ACI 318-19
Building Code Requirements for Structural Concrete and Commentary
Reported by ACI Committee 318
Errata may already be included in the print version you own

ERRATA as of July 7, 2022

Fig. R6.6.5—Permissible redistribution of moments for minimum rotation capacity.

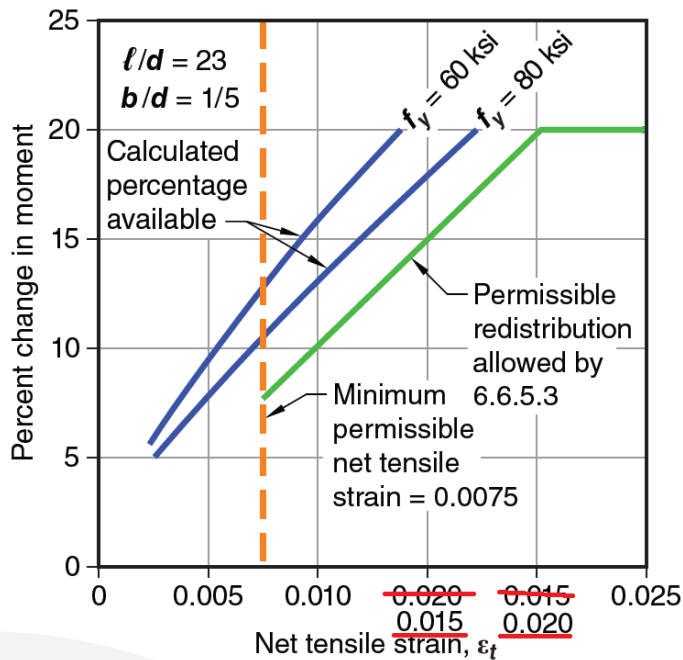
p. 84, Fig. R6.6.5, revised as follows:
